# **CENTRAL LAND COUNCIL**

**Submission to the NT Government on**

**Draft Western Davenport Water Allocation Plan 2023-2033**

**12 May 2023**

Figure - (Upper) Thring Swamp bore RN018338 (Lower) model calibration hydrograph from Knapton, (2017). Note the difference with the model prediction showing the bore fluctuating from ~2-6m below the surface instead of ~0-2m.

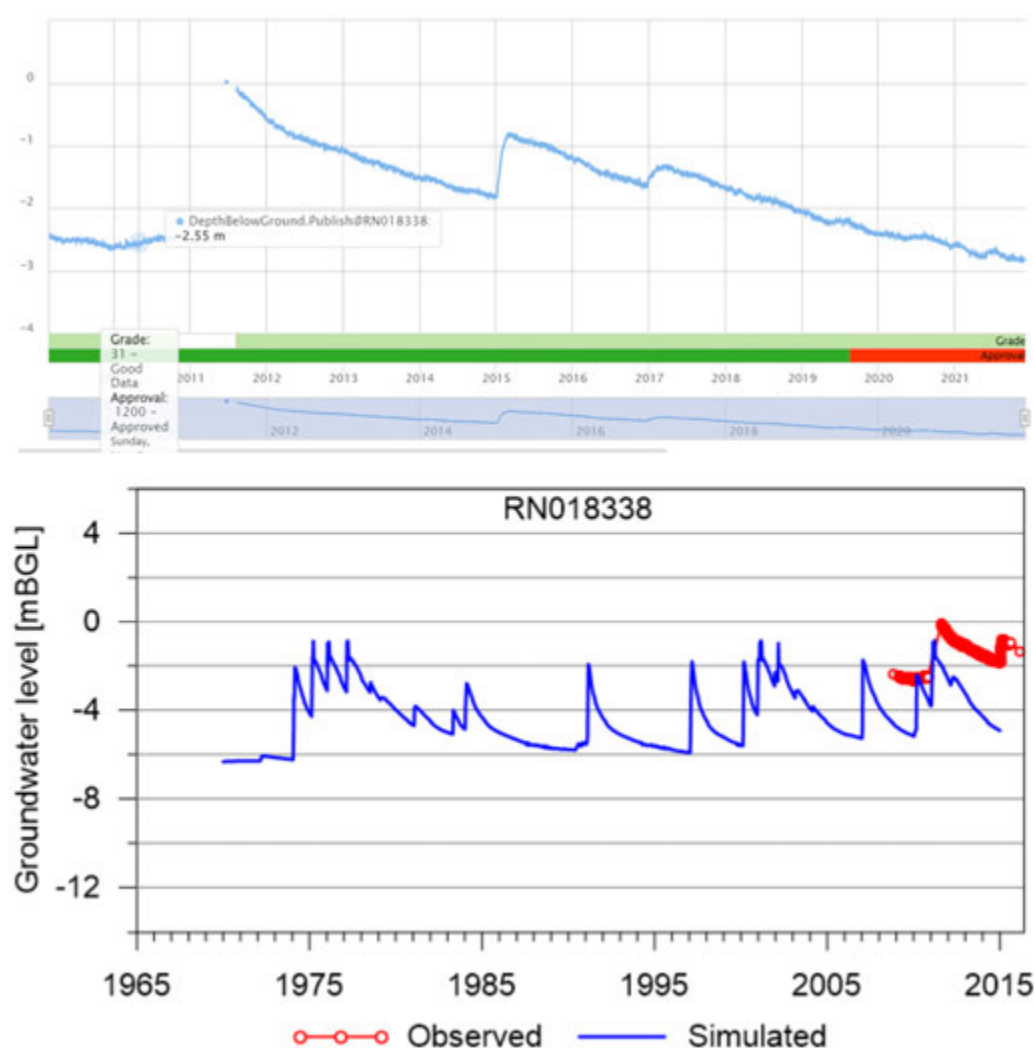
Thring Swamp (see figure below) show that the depth to groundwater at that location is consistently below 5m, has been 0m in 2011 (i.e. at the surface) and is generally about 1.5m. This area is predicted to impacted by drawdown but the lack of predictive uncertainty analysis of the groundwater modelling makes it difficult to assess the timing and magnitude of drawdown. The groundwater model does not accurately (see figure below) represent this important biodiversity asset/high cultural value site, which urgently needs a detailed assessment of aquifer connectivity and groundwater dependence. Showing all depth to groundwater contours <15m at 1m interval would be preferable to facilitate comparison with measured groundwater data.

Figure 6. Cumulative residual rainfall (mm) measured at Ali Curung (BoM Station ID 015502)

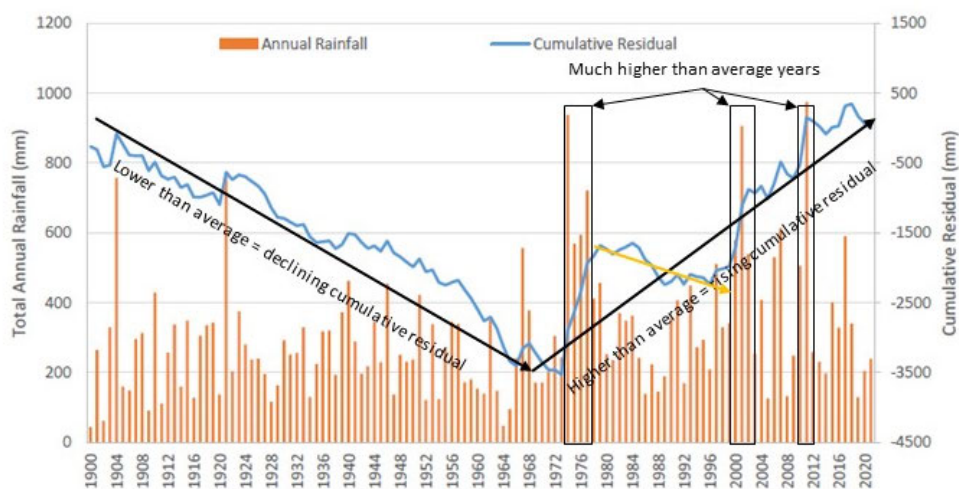
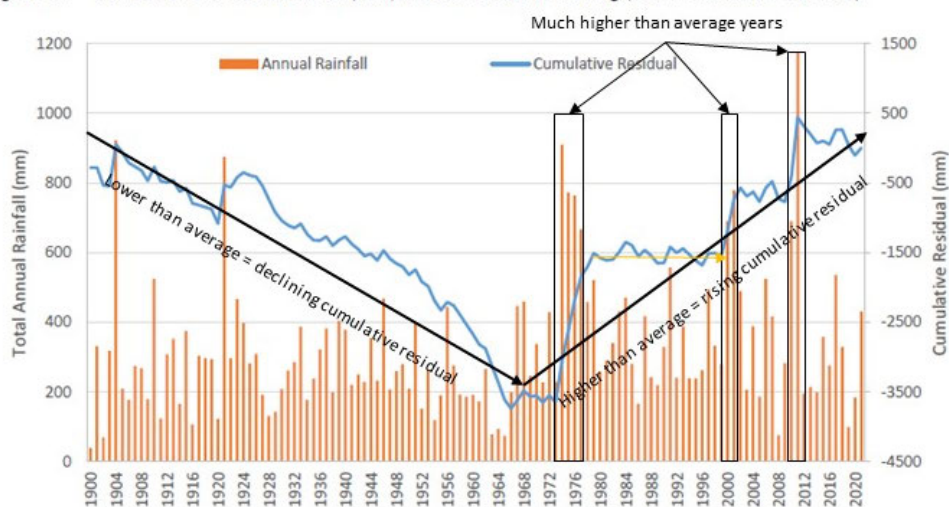
Page 13 - “Both charts provide evidence of an increasing trend in rainfall across the district since approximately 1972.”

Comment - The data isn’t that simple. An annotated version of the climate graph from the WAP background document is shown below. There is a period of average to less than average rainfall that spans 1980 to 2000 (see yellow arrows). The series of 4 significant rainfall years in the late 70’s accounts for about half of the “increasing rainfall trend” at Ali Curung. This effect is even more pronounced in the Barrow Creek dataset with rising trend in the 4 late 1970’s years, 2001, 2002, 2009 and 2010 accounting for this increasing trend.
